Re: PETITION NO. 1353 - The United Illuminating Company petition for a declaratory ruling pursuant to Connecticut General Statutes §4-176 and §16-50k for the proposed modifications to the existing Seaview Tap Substation located at 1677 Seaview Avenue, Bridgeport, Connecticut.

Enclosed please find the original and fifteen (15) copies of The United Illuminating Company's responses to the Siting Council's First Set of Interrogatories dated October 26, 2018 in connection with the above-referenced petition.

The United Illuminating Company
Petition No. 1353

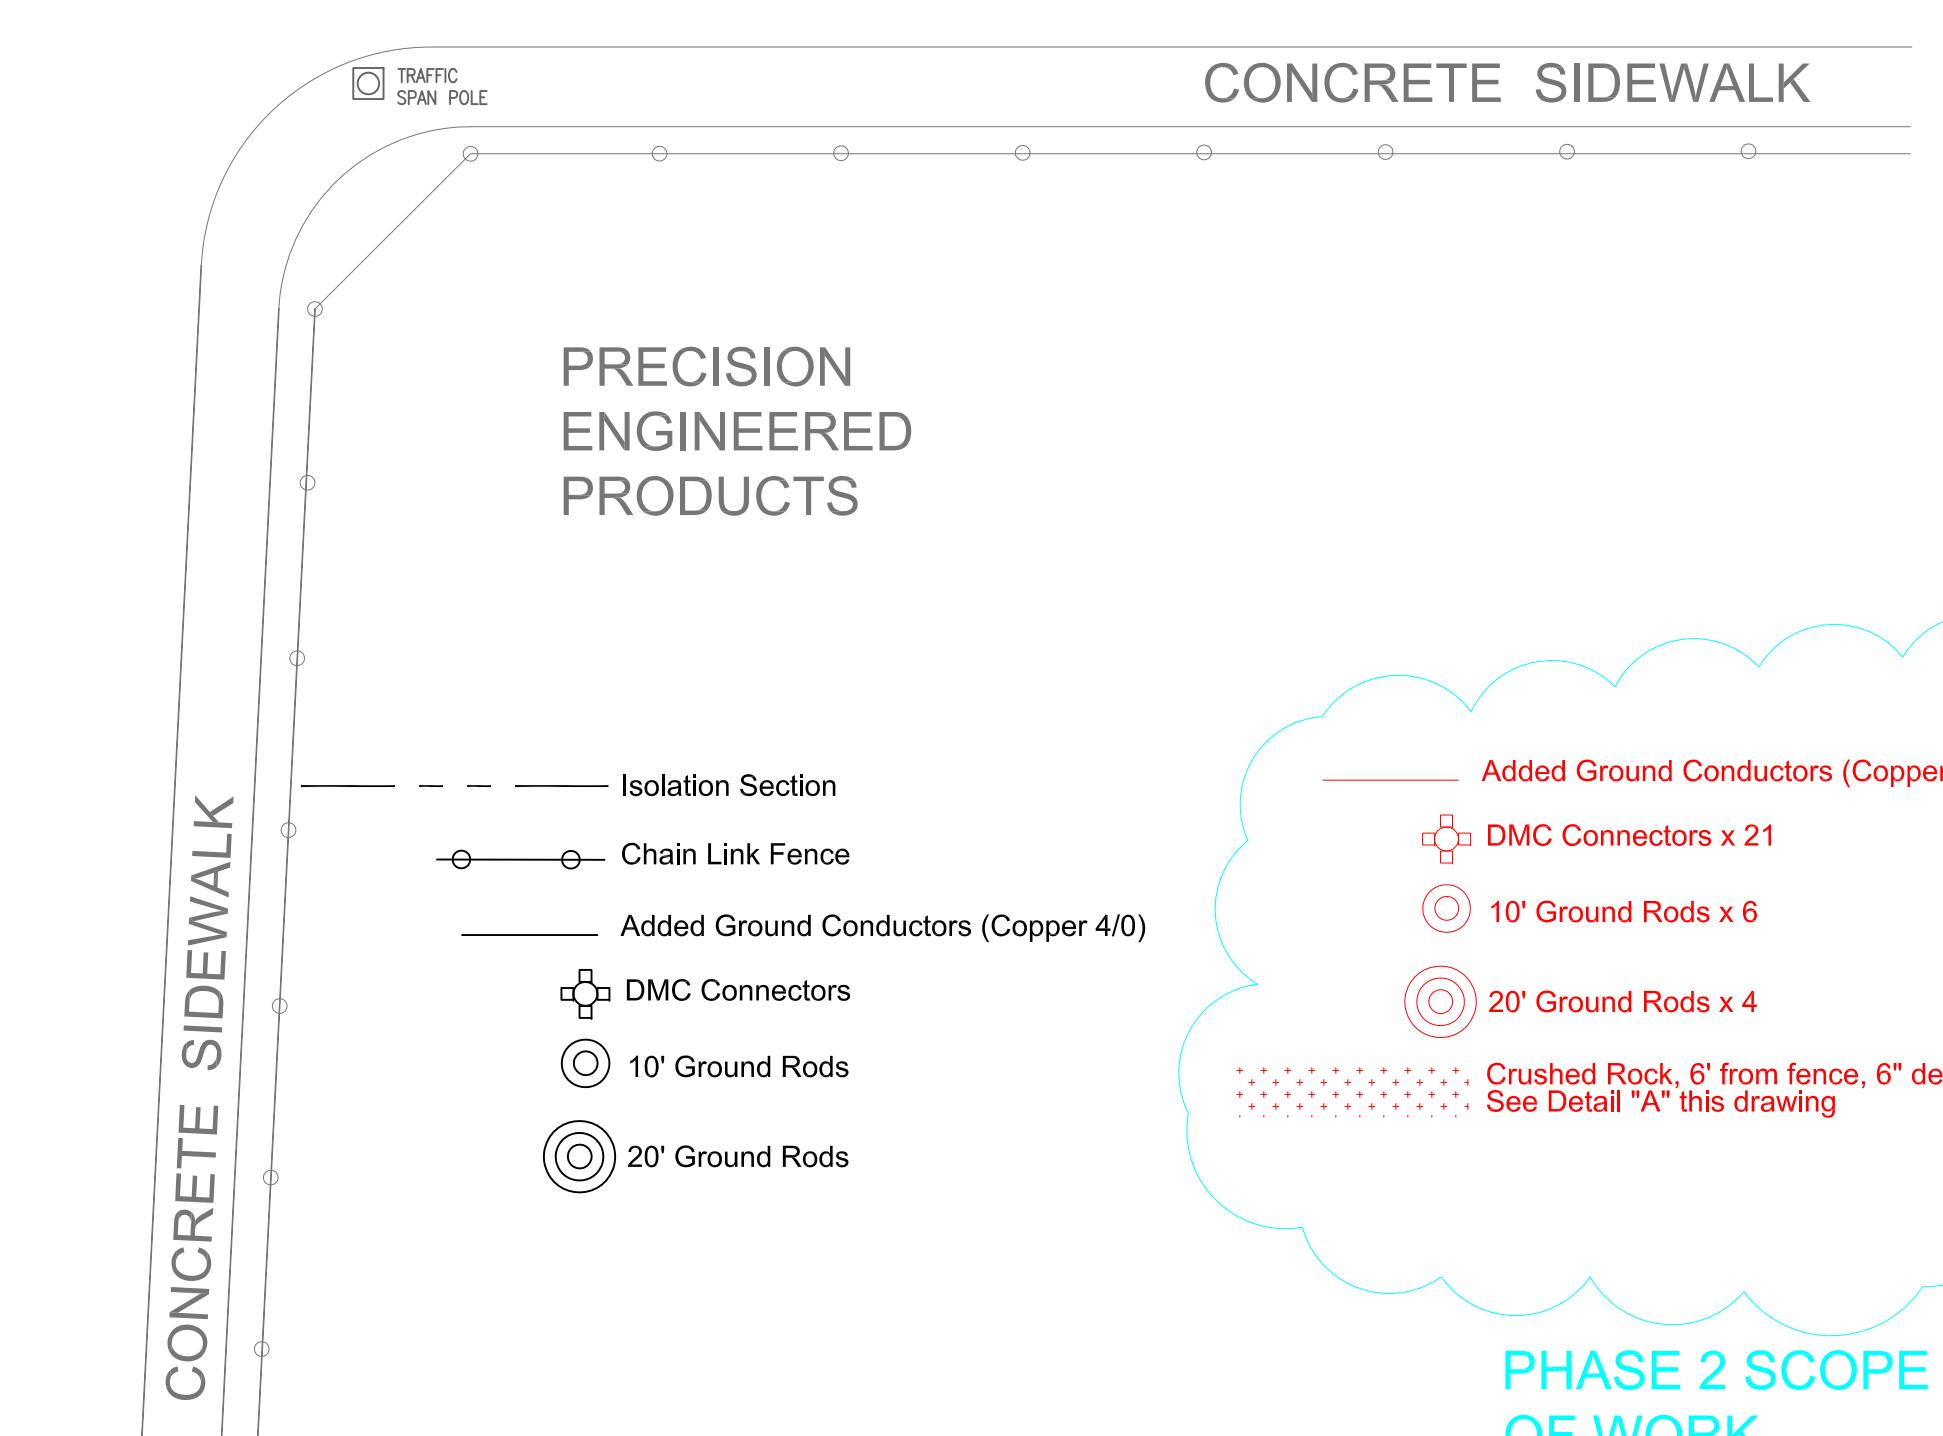
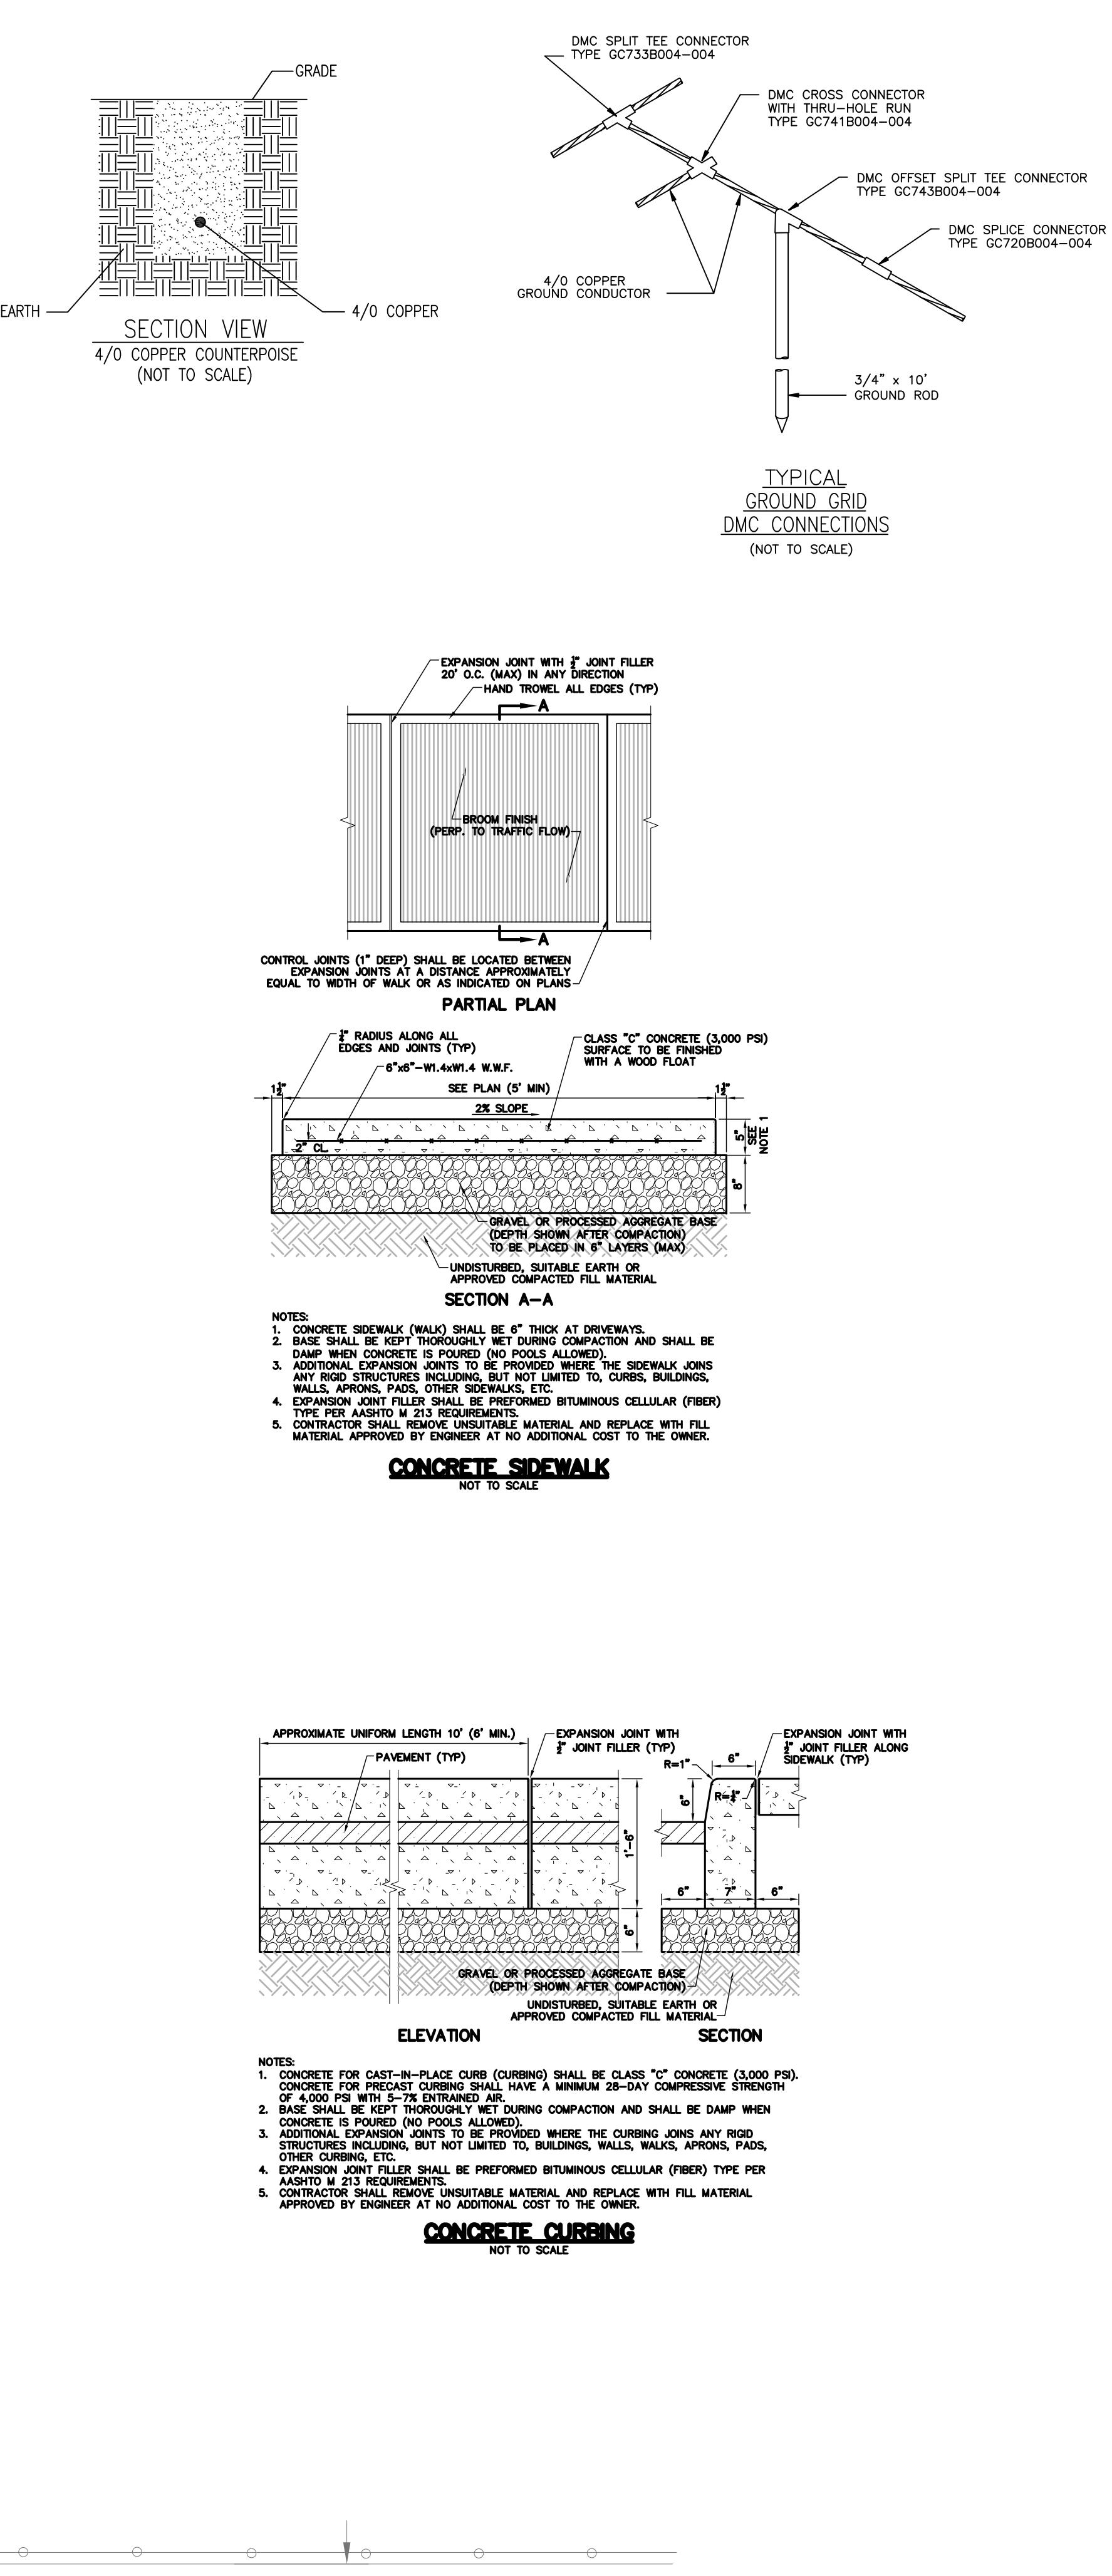
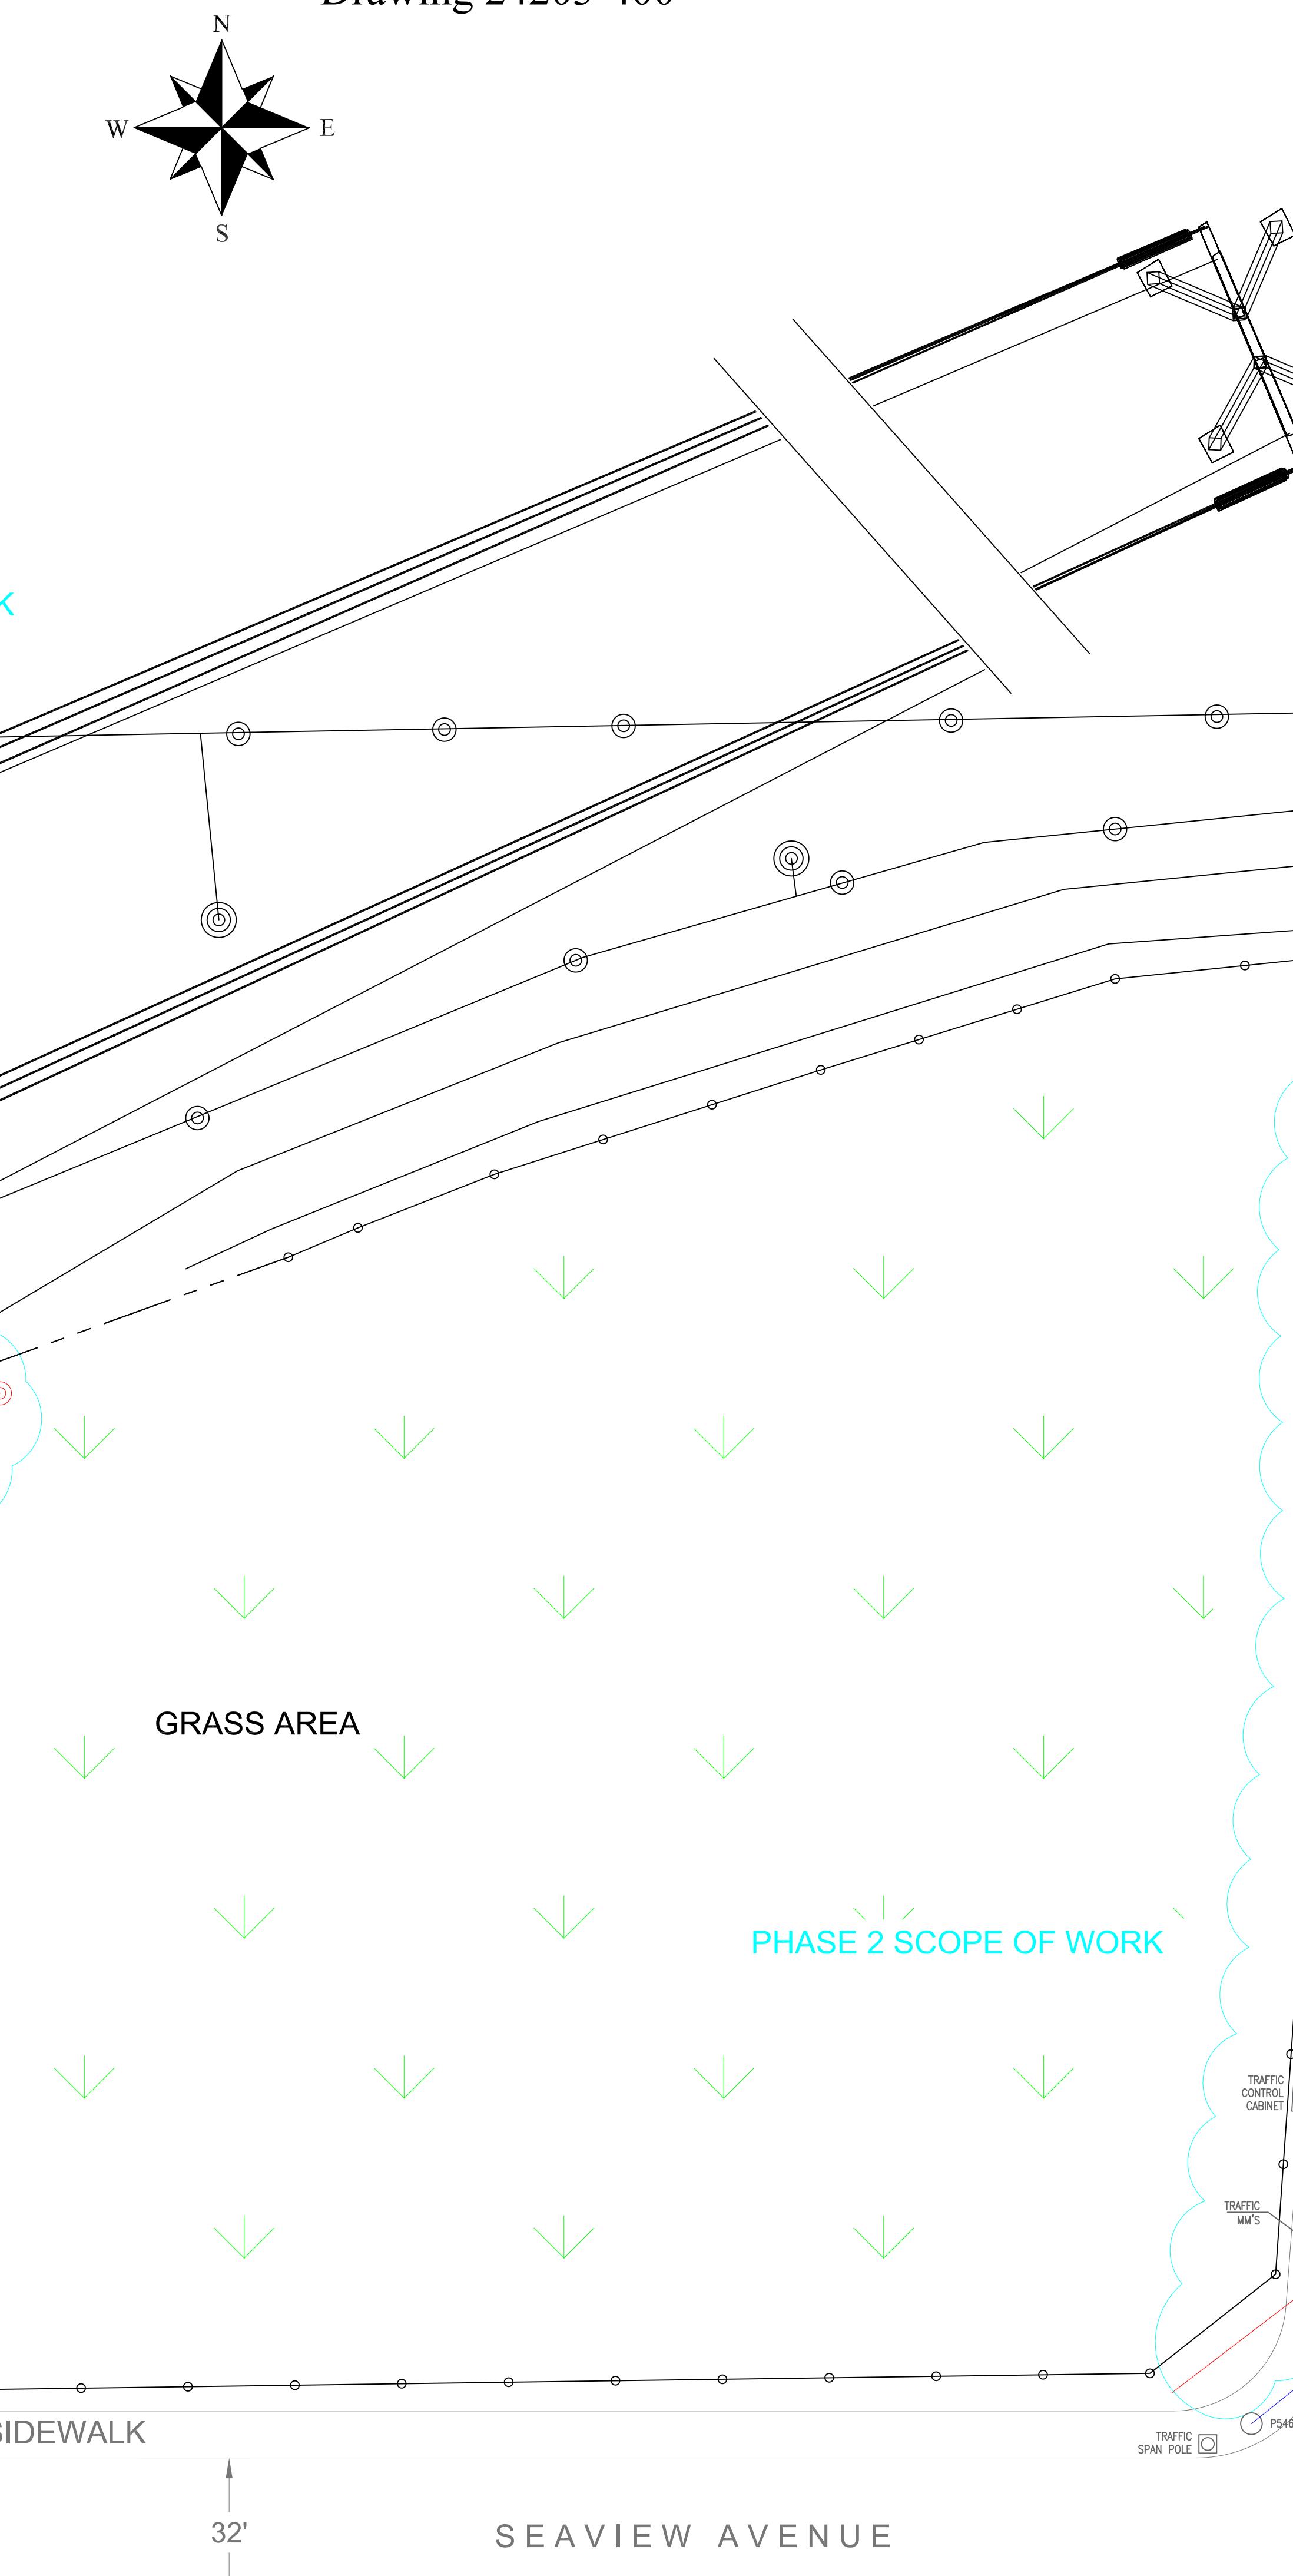
Q-CSC-I-1: Reference Drawing 24203-400 of the Petition dated October 19, 2018. The upper left portion of such drawing shows 180" (i.e. 180 inches) of added ground conductor on the western limits of the project. Was 180' (i.e. 180 feet) intended? Explain.

Q-CSC-I-7: Reference Drawing 24203-400 – Phase 2 Scope of Work. Why is crushed rock proposed on the northern and southern limits of the substation, but not necessarily coinciding with the proposed grounding work? Would crushed rock be added to any other areas of the proposed project?

A-CSC-I-1: This was a typo, and is supposed to read 180', not 180". See revised drawing 24203-400.

A-CSC-I-7: This was a mistake on the drawings. The crushed rock will be installed over the newly installed grounding conductors on the east and west sides of the substation fence. See revised drawing 24203-400.
